Service Bulletin

Bulletin No.: PIT5225

Subject: Front Door Window Belt Molding Retainer Bolt Corrosion

Models: 2014 Chevrolet Silverado 1500

3605356

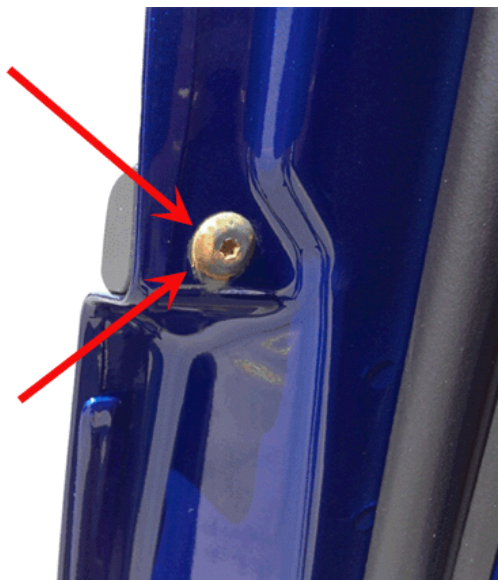
Some owners may comment that the front side door window belt molding retainer bolt is corroded, see photo below.

To correct this issue, replace the Bolt with GM Part # 11515397. Apply Red Thread Adhesive (GM Part # 89021297, Canada Part # 10953488 or equivalent) to the bolt threads and tighten to 27 lb-in (3 N-m).
